PUBLIC HEARING/WORKING SESSION MEMORANDUM

PETITION #317-19

67 Walnut Street

Special Permit/Site Plan Approval to allow three Single-Family Attached Dwellings with waivers from the dimensional standards and to allow a retaining wall of four feet in height within the setback.

Revised Front Elevation

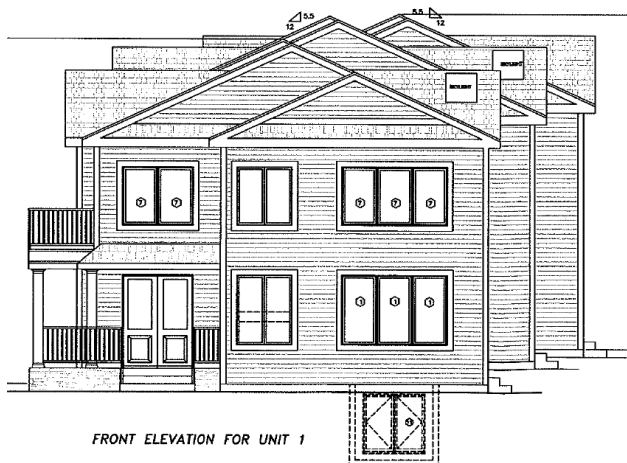
The petitioner submitted revised elevations which show more detail to the façade, specifically fish-scale shingles, lintels, and window hoods. These details sharpen the facade, while minimizing the presence of the articulations and the ridges of the middle and rear units. Staff discussed the elevation with the petitioner and with the City's Urban Designer who noted that although the elevation shows the ridges and peaks of the middle and rear units, these units are set back from the front façade, the middle unit is set back 32 feet, while the rear unit is set back approximately 63 feet. Additionally, the structure is built above the grade of the street which, when combined with the setback of the middle and rear units, would render the peaks and ridges not visible to pedestrians along Walnut Street. After review, staff is supportive of the revised elevation.
